**The 13th Meeting of the Department of Computer Science and Technology
Buildings and Environment Committee**

10 a.m. on Friday, 7 February 2020, Room SW00, William Gates Building

**The 12th Meeting of the Department of Computer Science and Technology
Buildings and Environment Committee**

PM1119
 JJ THOMSON CYCLE STORE EXPANSION

OPTION 1

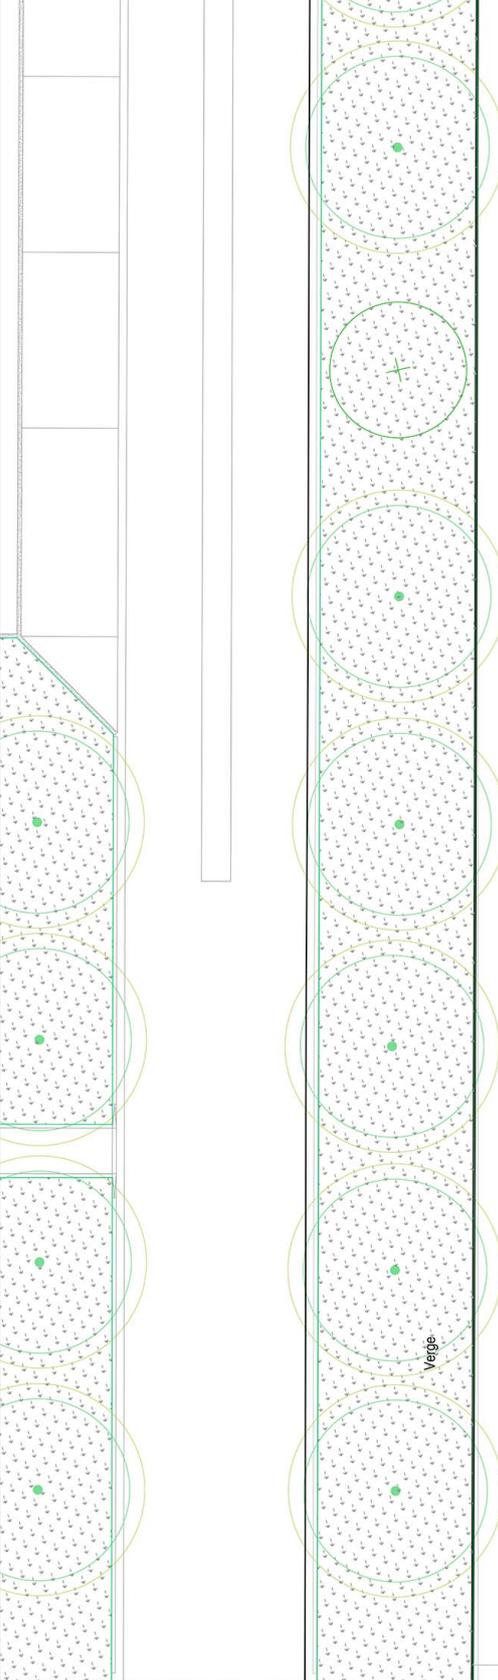
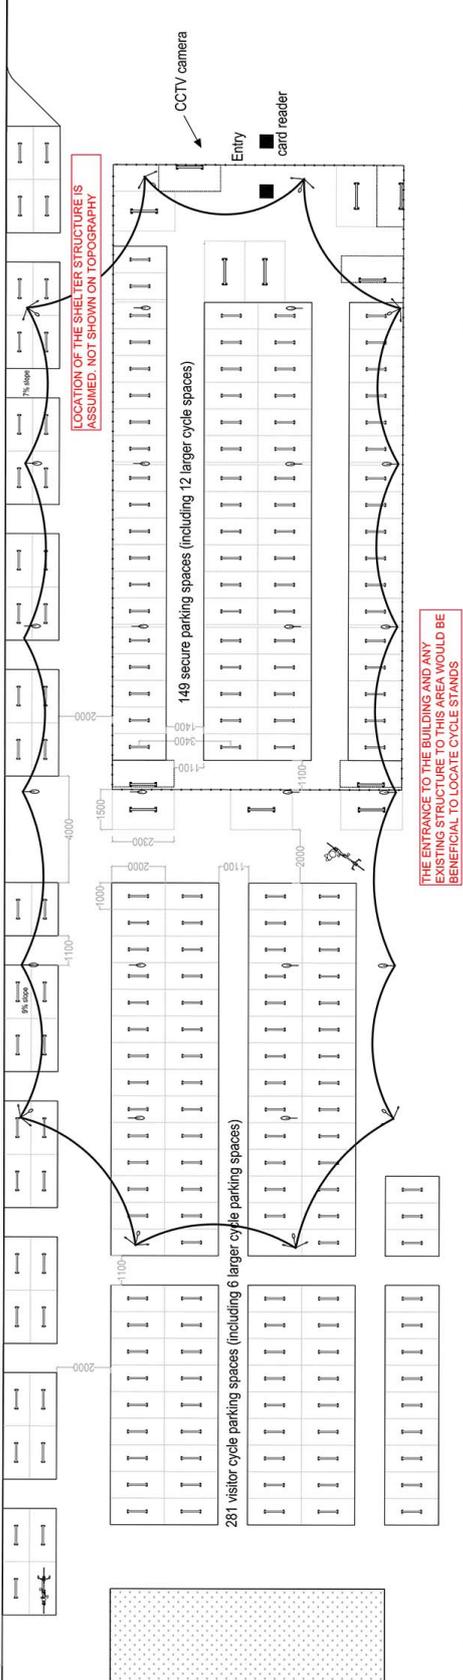
- (1) expands the Sheffield stands over the existing grassy area,
- (2) puts Sheffield stands underneath the overhang next to the cafe, along the blank area of wall (that is, blank apart from the building vents).

EXISTING FOOTPATH SHOWN AS CYCLEWAY AT PROVIDED DIAGRAM

THIS IS CYCLEWAY AT MASTERPLAN PROVIDED BY AECOM. IT IS NOT SHOWN AS CYCLEWAY AT THE MOMENT. IT SHOULD BE 3M FOR BI-DIRECTIONAL CYCLEWAY. IT IS 2M AT THE MOMENT.

LOCATION OF THE SHELTER STRUCTURE IS ASSUMED. NOT SHOWN ON TOPOGRAPHY

THE ENTRANCE TO THE BUILDING AND ANY ENTRANCE STRAITS SHOULD BE BENEFICIAL TO LOCATE CYCLE STRAITS

LINE IN AECOM MASTERPLAN - PLEASE CONFIRM DESIGN INTENT

OPTION 2

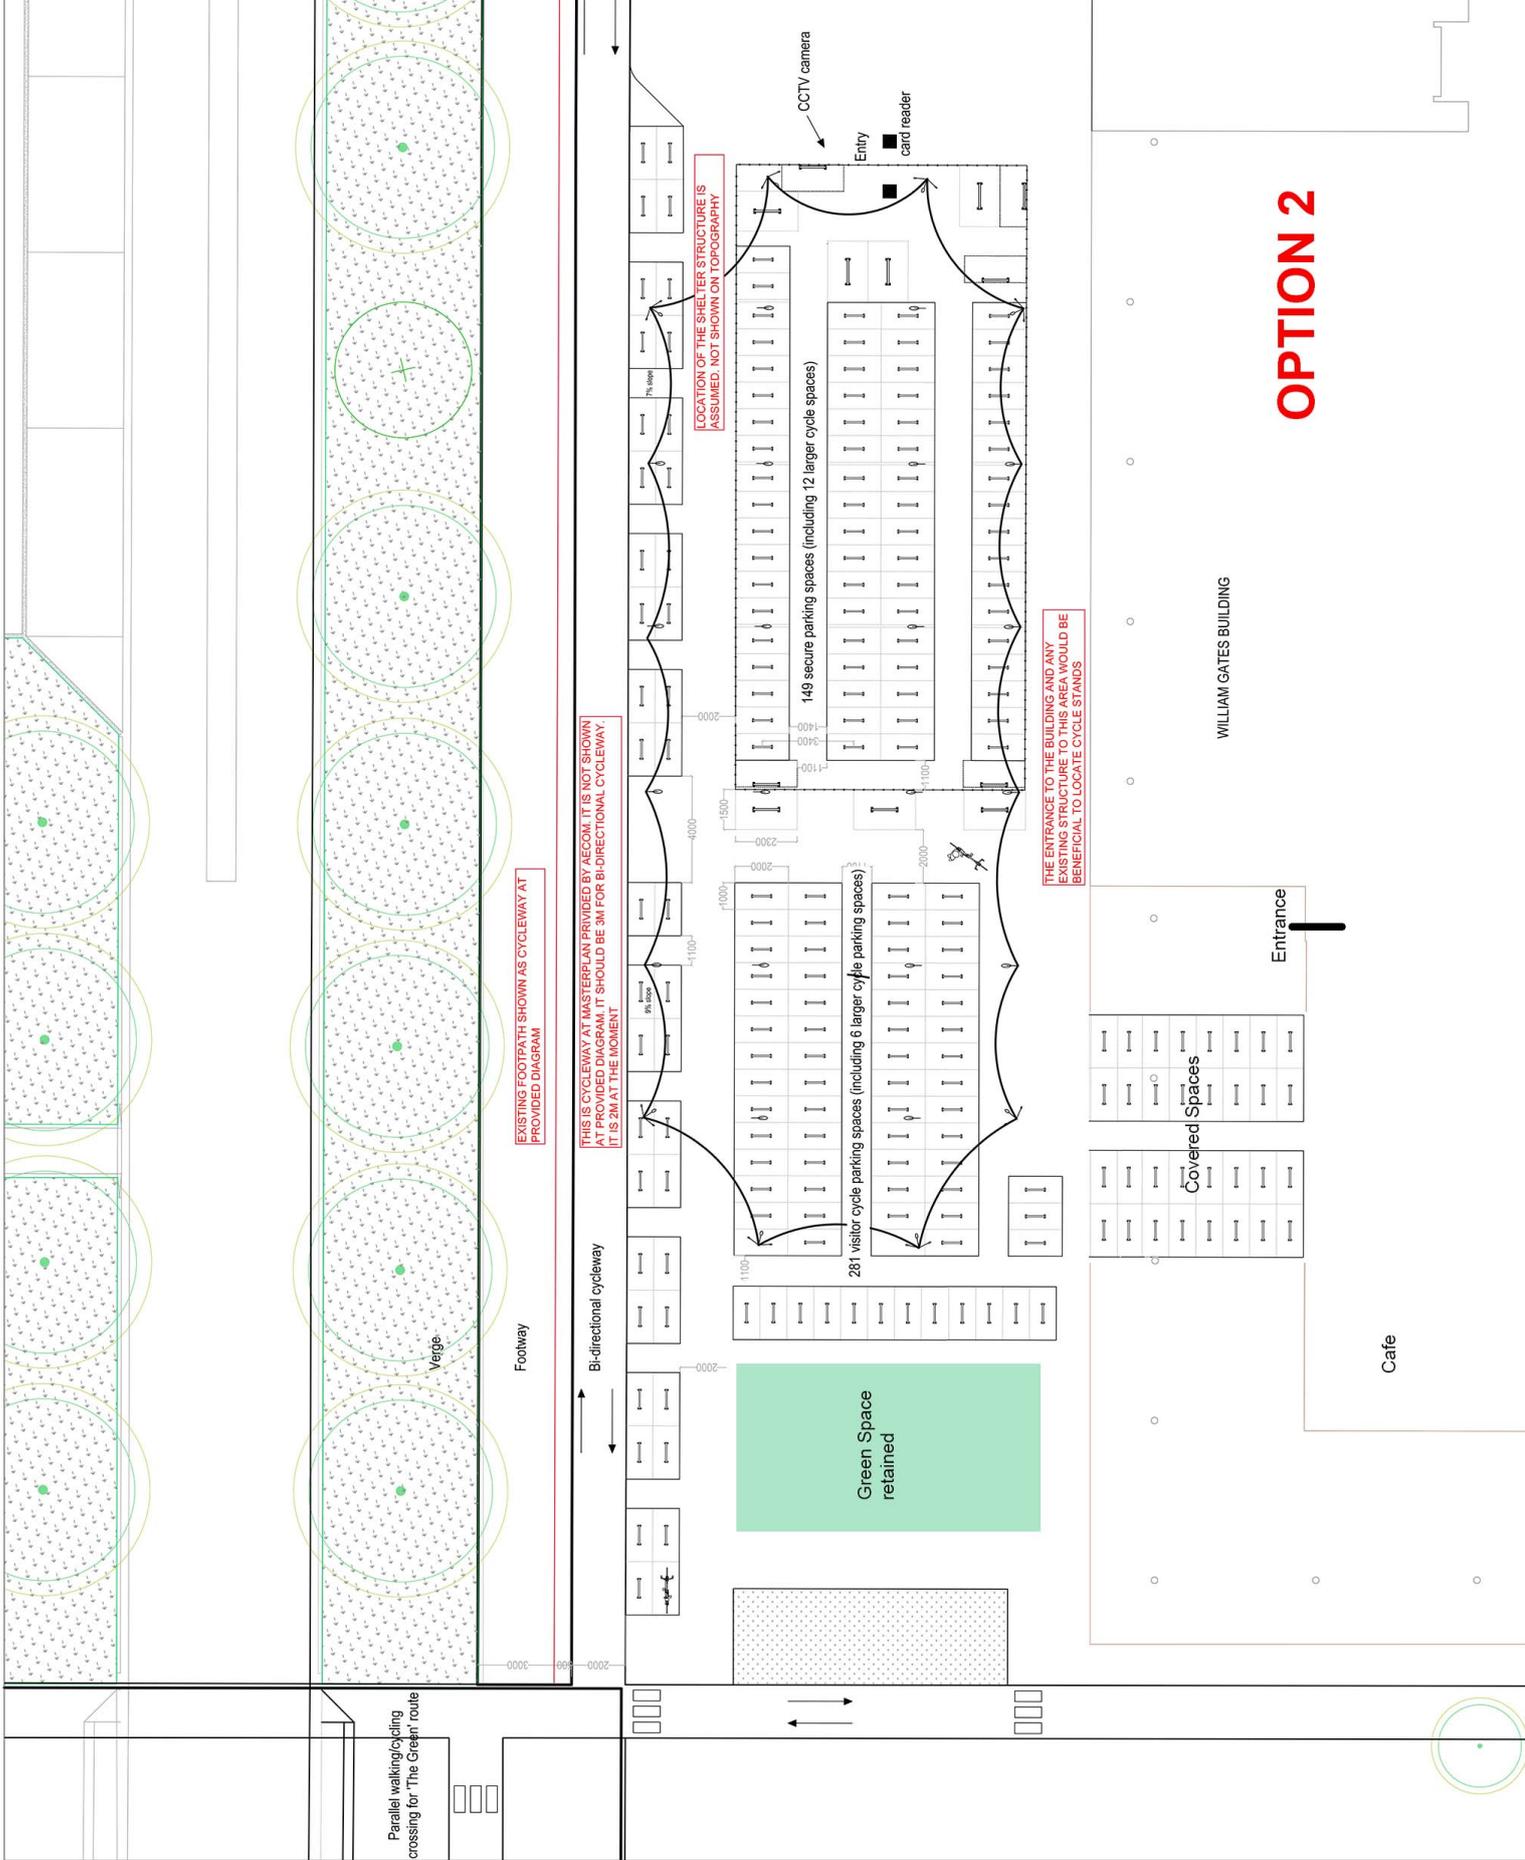
I have talked in person with about 15 people and the general feeling has been a preference for Option 2 and keeping more of the grass intact, as well as covering more of the stands.

Several people noted that with Option 2, it should be modified such that there is a wider space for walking between the building door and the pathway to the street. I would like to know if there are any other issues with the use of this space.

LINE IN AECOM MASTERPLAN - PLEASE CONFIRM DESIGN INTENT

EXISTING FOOTPATH SHOWN AS CYCLEWAY AT PROVIDED DIAGRAM

THIS IS CYCLEWAY AT MASTERPLAN PROVIDED BY AECOM. IT IS NOT SHOWN AT PROVIDED DIAGRAM. IT SHOULD BE 3M FOR BI-DIRECTIONAL CYCLEWAY. IT IS 2M AT THE MOMENT

LOCATION OF THE SHELTER STRUCTURE IS ASSUMED. NOT SHOWN ON TOPOGRAPHY

THE ENTRANCE TO THE BUILDING AND ANY EXISTING STRUCTURE TO THIS AREA WOULD BE BENEFICIAL TO LOCATE CYCLE STANDS
